Meeting Agenda

Franklin Municipal Planning Commission

Thursday, August 28, 2014

**SITE DEMOLITION
& EXISTING
CONDITIONS
PLAN**

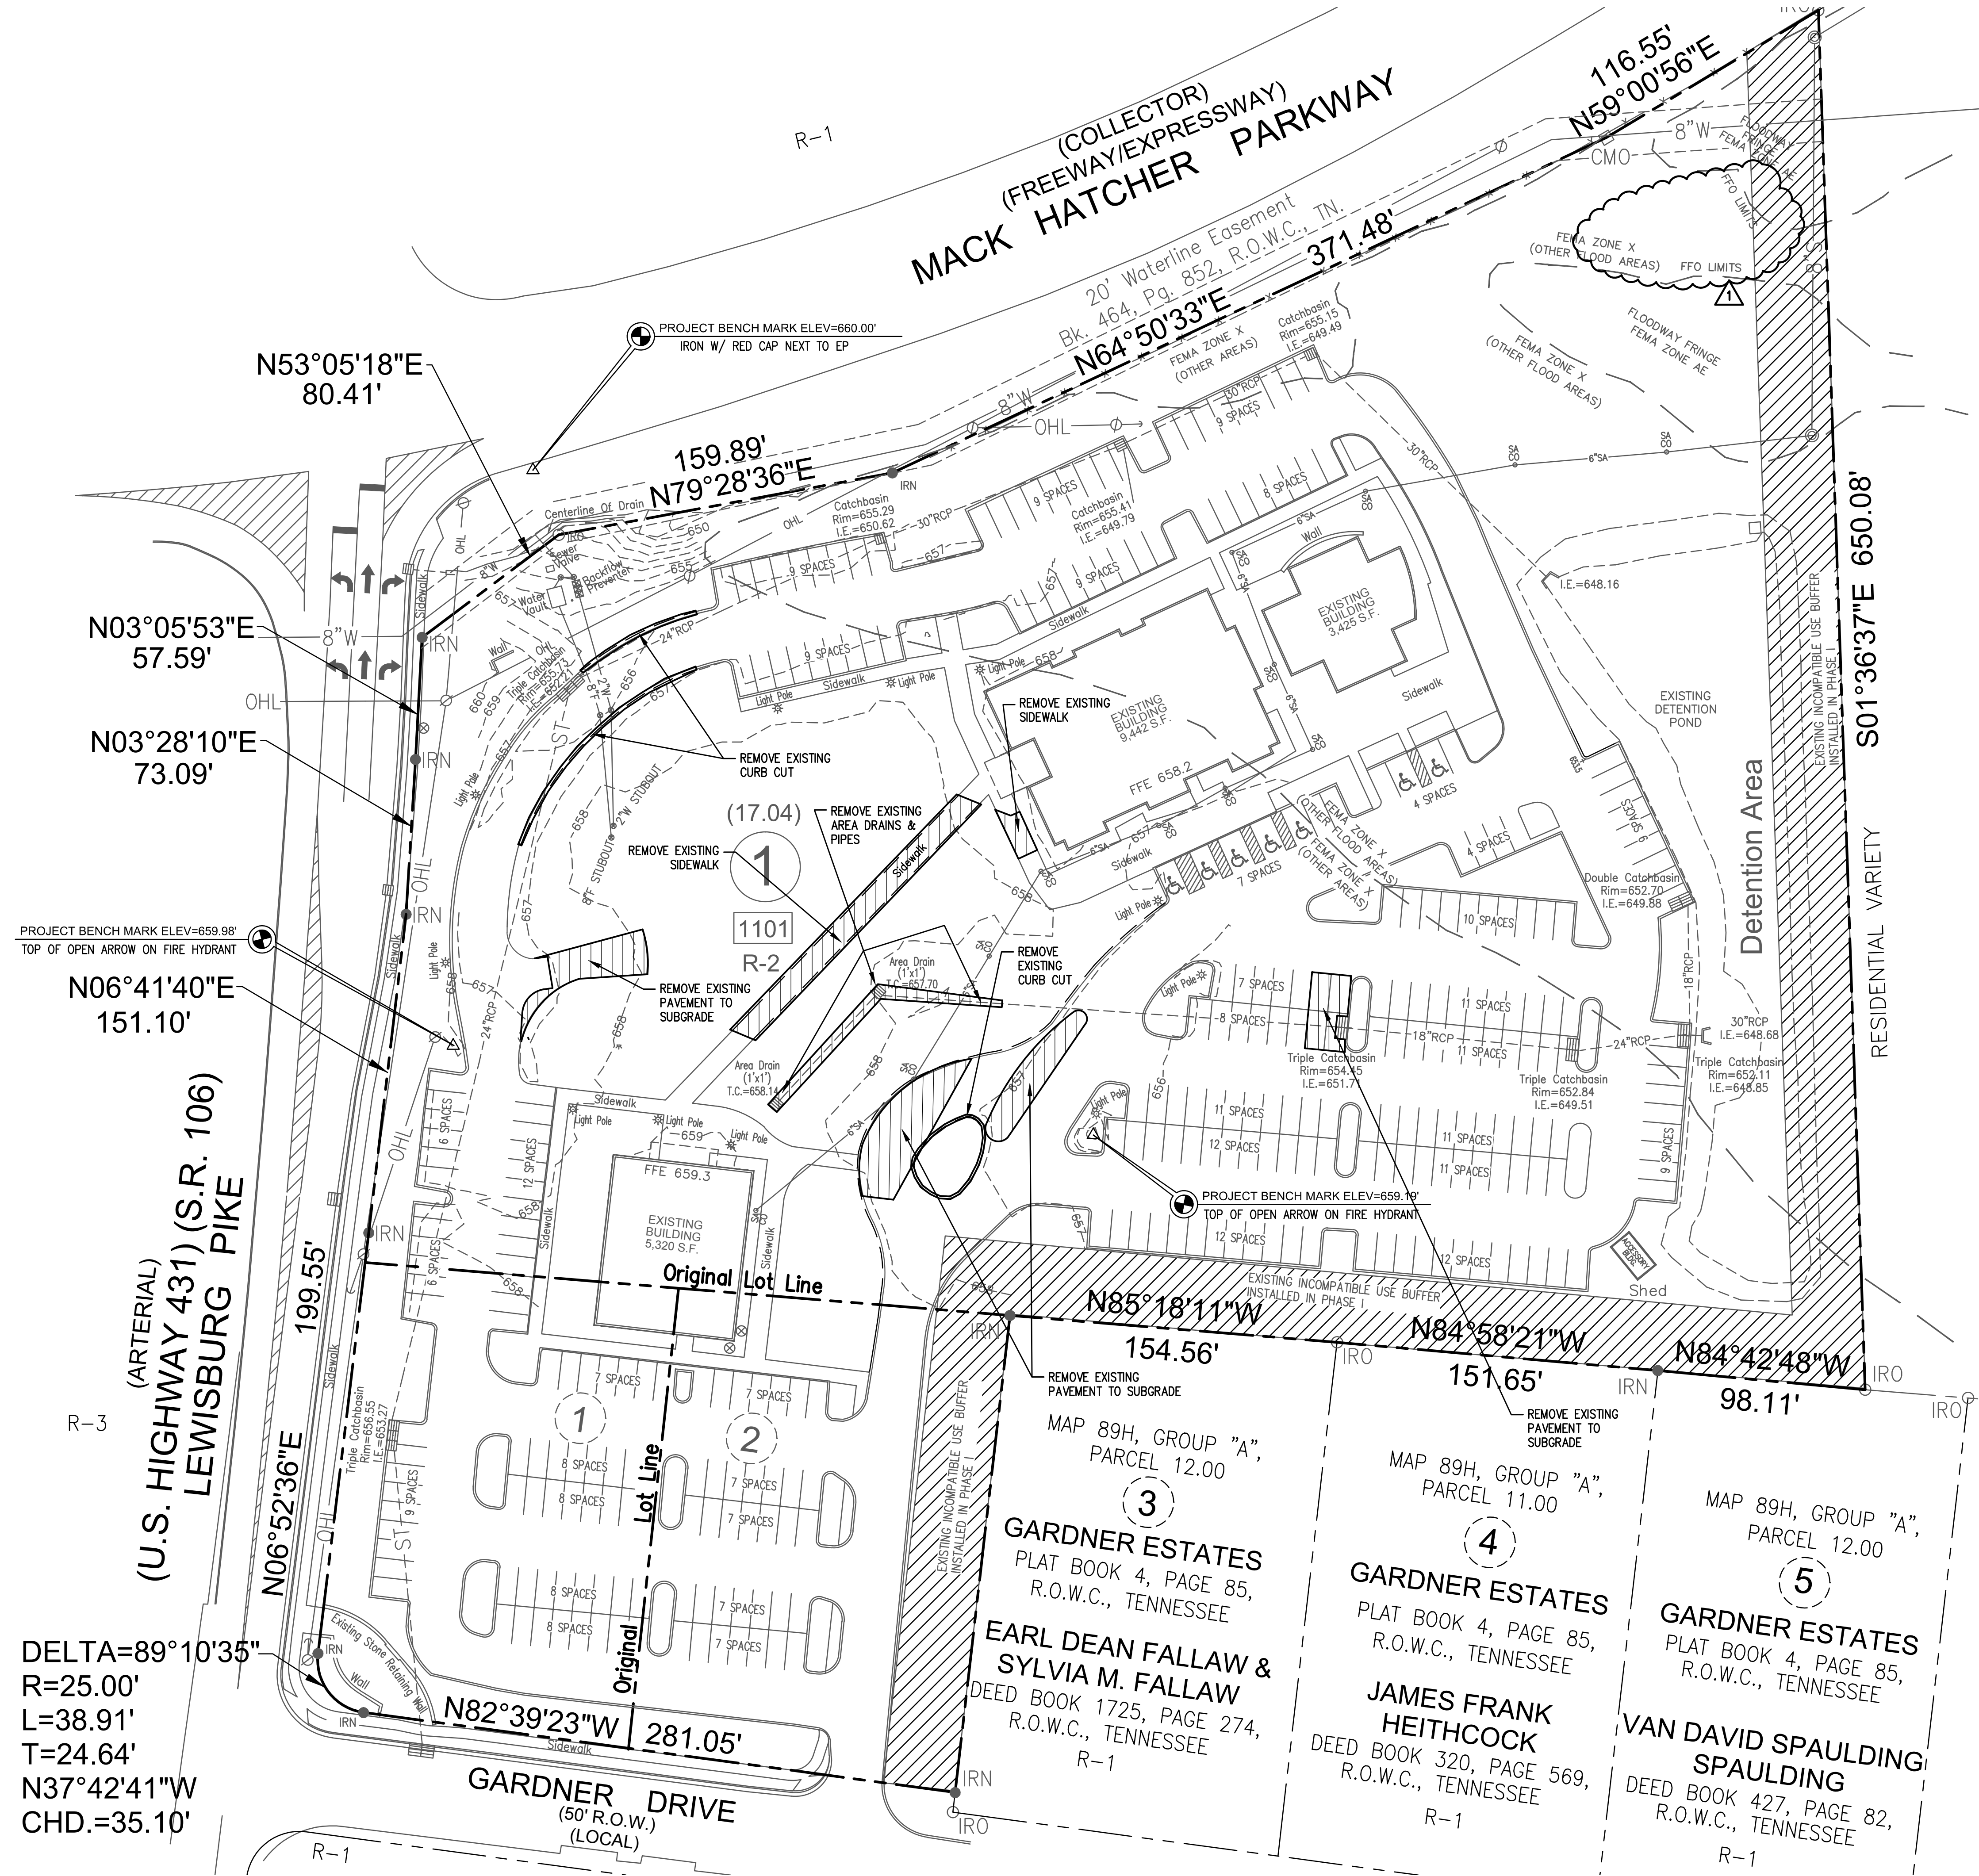
- The applicant shall correctly label the FFO overlay limits, as shown on City of Franklin zoning maps, on the existing conditions plan sheet and the site layout plan sheet.

SITE LAYOUT
PLAN

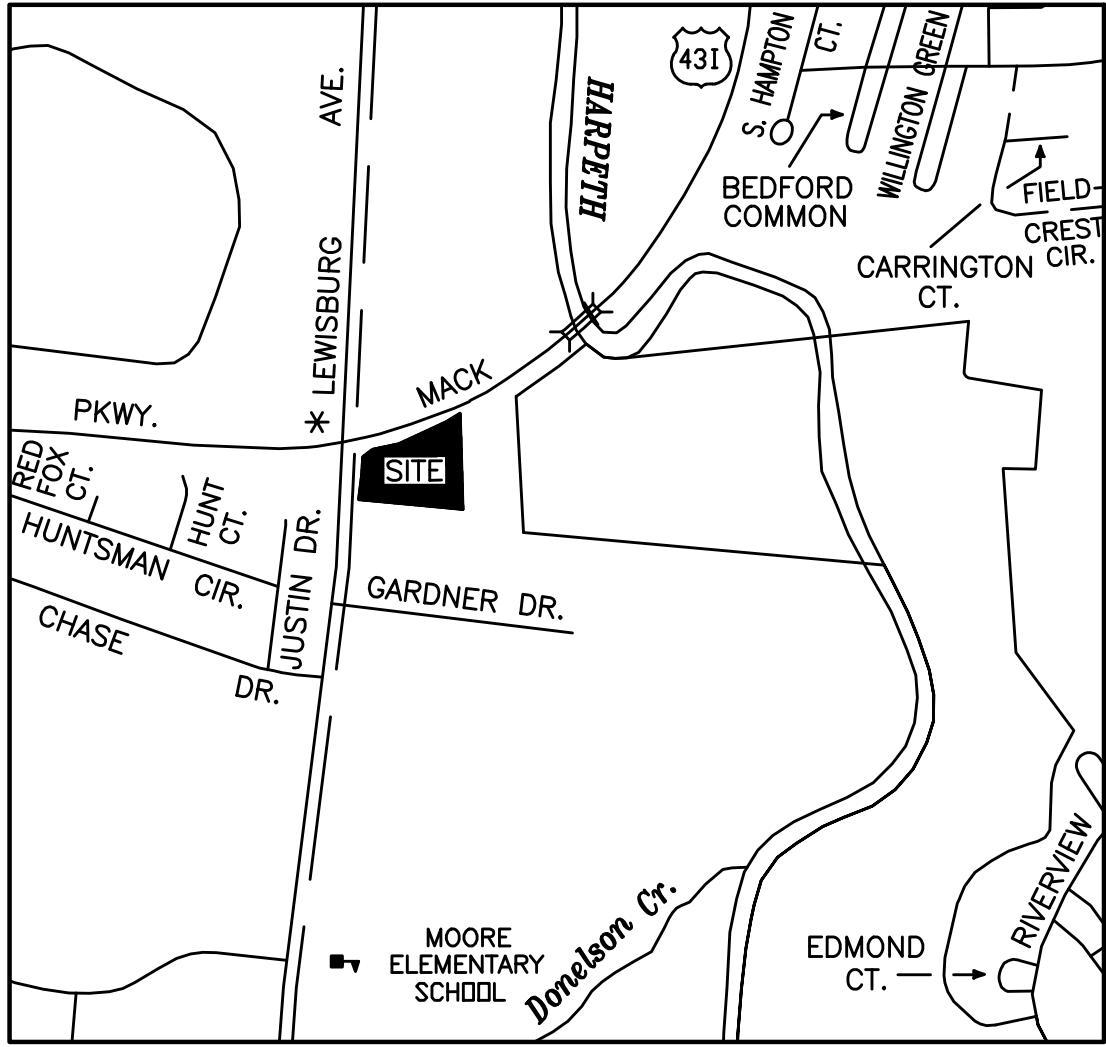
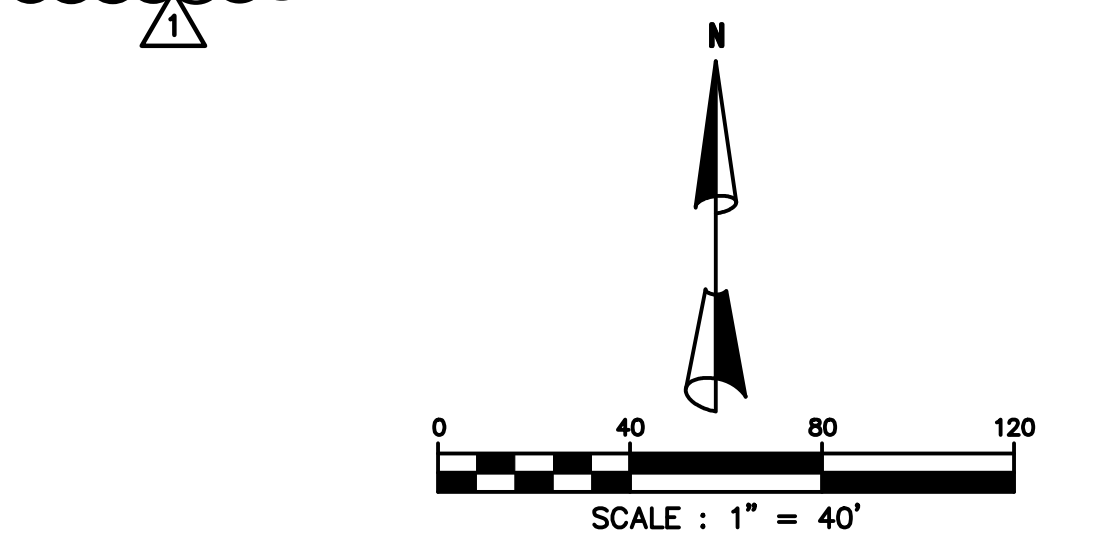
- The applicant shall revise the Parking Summary on the Site Layout Plan page. The maximum parking spaces shall not be fewer than the minimum required parking spaces.
